UNITED STATES PATENT AND TRADEMARK OFFICE

Office Action Summary

10/537,828

DETAILED ACTION

F I G. 1

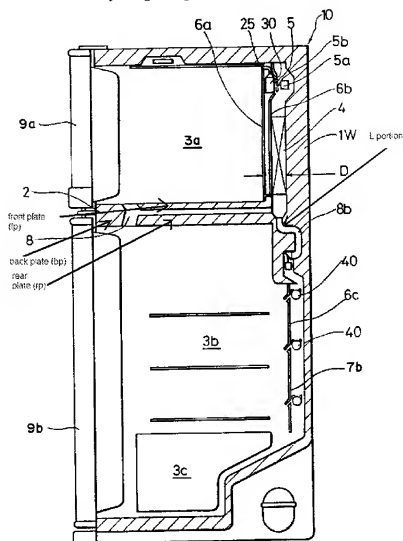
Lee et al. also teach a partition wall (rp) between the freezing chamber cold air passage (passage between 8 and 8b) and the refrigerating chamber cold air passage (7b) (see annotated Fig. 1 below), the evaporator (4) passing through the partition wall (rp) such that the evaporator (4) is exposed to the freezing chamber cold air passage and the refrigerating chamber cold air passage (see annotated Fig. 1 below). The evaporator (4) is directly exposed to the freezing chamber (3a) and separated from the freezing cover by the casing of the evaporator (6a) (see annotated Fig. 1 below). The piping of the evaporator (4) and lower portion of the evaporator passes through the back end of the refrigerating chamber (3b) passing through the very right bottom end of the partition wall (see Fig. 1). A pipe is considered to be a hollow cylinder used to convey a medium meeting the limitations of a passage which is an opening used to convey something.

Lee et al. also teach a fan (5) mounted over the freezing chamber cold air passage (passage between 8 and 8b) and the refrigerating chamber cold air passage (7b) (see Fig. 1 and col 1 lines 22-23) for discharging cold air flowing through respective cold air passages (7b, 8) to the freezing chamber (3a) and the refrigerating chamber (3b), respectively (see Fig. 1). The fan (5) forces air into the freezing chamber (3a) and refrigerating chamber (3b) using the partition plate (6b) to direct the airflow of the coming from the fan (5). It is presumed that the fan

In regard to claim 2, Lee et al. teach the refrigerator (10) wherein the evaporator (4) includes a first part exposed (exposed through vent 6a – see Fig. 1) to the freezing chamber cold air passage (passage between 8 and 8b) (see Fig. 1) and a second part (8b) exposed to the refrigerating chamber cold air passage (7b) (see Fig. 1). The face of the evaporator adjacent to the vent 6a is exposed to the chamber cold air passage via the duct 8. The second part (8b) tubing extends from the bottom side of the evaporator (4) to enter the refrigerating chamber cold air passage (7b).

In regard to claim 3, Lee et al. teach the refrigerator (10) wherein the first part (6a) is larger than the second part (8b) (see Fig. 1). The surface area of the first part (6a) facing the freezing compartment (3a) is larger than the surface area of the second part (8b) facing the opening to the refrigerating compartment (3b) (see Fig. 1).

In regard to claim 4, Lee et al. teach the refrigerator (10) wherein an outer surface of the first part (6a) and the second part (8b) is separated by the partition wall (rp) for preventing the cold air flowing through the respective parts from mixing with each other (see Fig. 1).

In regard to claim 5, Lee et al. teach the refrigerator (10) wherein the partition plate (rp) includes a front plate (fp) and a back plate (bp) to form a cold air passage (see passage between fp and bp connected between passage 8) between the plates (fp, bp) (see annotated Fig. 1 above).

In regard to claim 6, Lee et al. teach the refrigerator (10) wherein the front plate (fp) has a plurality of cold air discharge openings (opening at 8 and opening at

8b) formed therein (see annotated Fig. 1 above). The front plate has an opening to let air exchange between the refrigerating chamber (3b) and freezing chamber (3a) via opening 8. There is a second opening above 8b to let air exchange with the fan and evaporator (4) as seen in annotated Fig. 1 above.

In regard to claim 7, Lee et al. teach the refrigerator (10) wherein the back plate (bp) has an opening in an upper part thereof (into 8b) and the fan (5) is provided adjacent to the openings (8, 8b) (see Fig. 1). The fan (5) is adjacent via the evaporator (4) (see annotated Fig. 1 above).

In regard to claim 8, Lee et al. teach the refrigerator (10) wherein the partition plate (1w) has openings (8, 8b) in a lower part thereof to form cold air suction openings (see annotated Fig. 1 above). The front plate has an opening to let air exchange between the refrigerating chamber (3b) and freezing chamber (3a) via opening 8. There is a second opening above 8b to let air exchange with the fan and evaporator (4) as seen in annotated Fig. 1 above.
